2CAN090601

Subject: Response to Request for Additional Information on ANO-2 Steam Generator
Tube Inservice Inspection Report
Arkansas Nuclear One – Unit 2
Docket No. 50-368
License No. NPF-6

**Response to NRC Request for Additional Information on
Steam Generator Tubing Inservice Inspection Report**

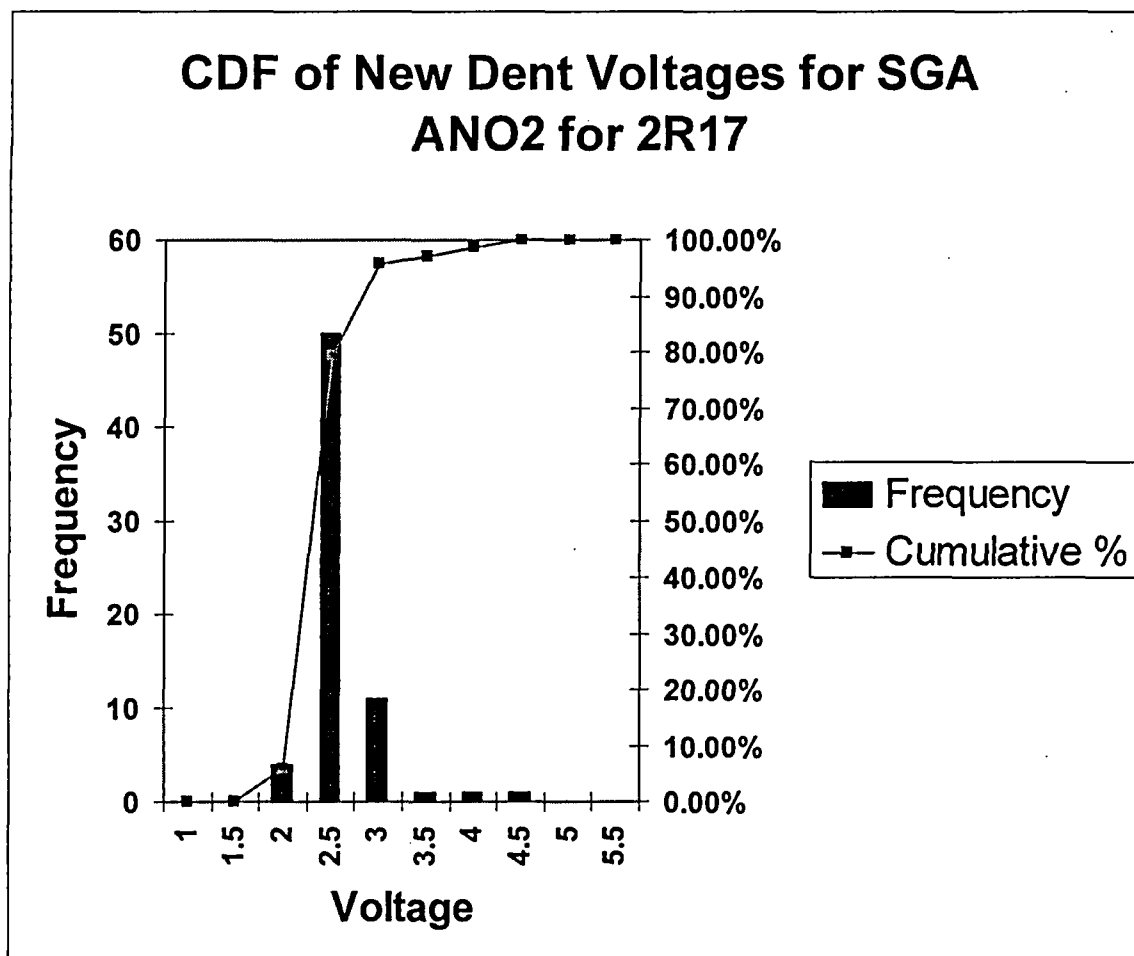
NRC RAI 1 *Discuss the scope and results of any dent and ding exams performed during the Cycle 17 steam generator (SG) tube inservice inspections. Please discuss whether any rotating probe exams were done and include the number of dents/dings in each SG. In addition, discuss whether there were any new dents/dings identified (if so, causal mechanism), whether there were changes in the dent/ding signals (if so, causal mechanism), whether any "anomalous" dent signals were identified, and the inspection criteria (e.g., greater than or equal to 2-volts).*

Dents/dings are identified with the bobbin campaign. The scope from 2R17 was 54% of the tube population. A review was performed to compare the dents/dings from 2R15 (spring 2002) to 2R17 (spring 2005). 2R15 was the first inservice inspection (ISI) after one cycle of operation and included 100% of the tubing. Both generator results were consistent with steam generator A (SGA) having the largest population of dents. Therefore, for this report, SGA data is being reported. A cumulative distribution factor (CDF) of the change in voltage for dents identified in both outages was performed. The mean change was approximately 0.6 volts which is considered an insignificant change based on the technique. This is presented in the graph below:

A review was performed of newly identified dents in 2R17. These were determined to be a function of the threshold limit of 2.0 volts as the vast majority of the newly reported dents were at this value. From the graph below, the majority of the dents remain at or near the detection threshold. Based on this data, the relative condition of the dents in the ANO-2 steam generators is not changing.

Figure 1
ANO-2 Replacement Steam Generator Tubesheet

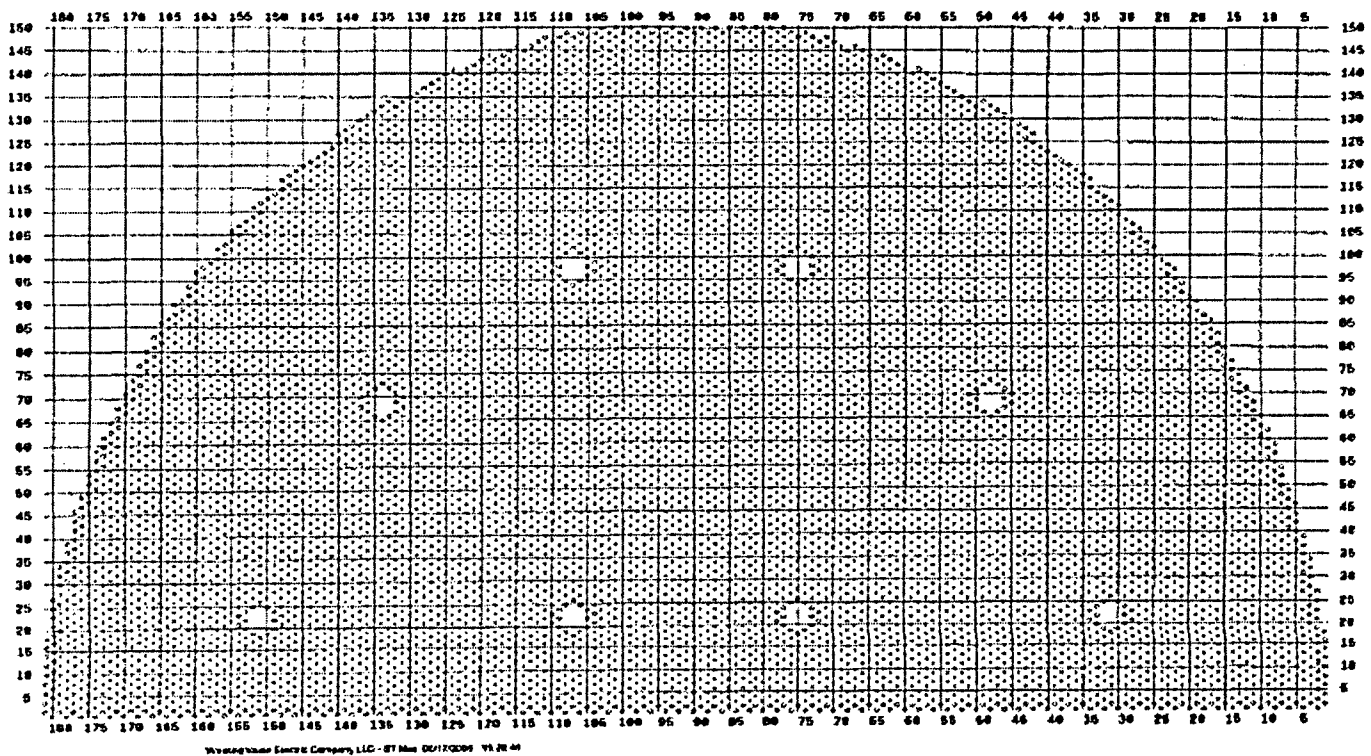
NRC RAI 4. *Your report provided information about flaws in specific tubes and at specific locations within a tube. In order for the U.S. Nuclear Regulatory Commission staff to better understand where your indications are being detected and for future reference, please provide the following information regarding the design of your replacement SGs: tube manufacturer, a tubesheet map, the tubesheet thickness (with and without the clad), the tube support plate thickness, the smallest U-bend radius and corresponding row, and a description of the U-bend support system, including the shape and thickness, and the tubing supported by the various supports. In addition, discuss whether you have a flow distribution baffle to distribute flow at the top of the tubesheet, including the thickness and hole shape.*

General design details of the ANO-2 replacement steam generators are contained in Section 5.5.2 of the ANO-2 Safety Analysis Report (SAR). SAR Figure 5.5-7 provides a cutaway depiction of the ANO-2 replacement SGs. The following are specific details of the replacement SGs:

Design of replacement SG	Westinghouse Delta 109
Tube Manufacturer	Sandvik
SG Tubes	10637 per SG Alloy 690TT 0.688" nom OD 0.04" nom wall thickness
Tubesheet Map	See Figure 1 (attached)
Tubesheet Thickness	31.13" for tubesheet forging 0.43" primary clad thickness
Tube Support Plate Thickness	1.115 inches
Smallest U-bend Radius	3.250 inches (Row 1)
Flow Distribution Baffle	ANO-2 does not have a baffle
U-bend Support System:	Anti-Vibration Bars
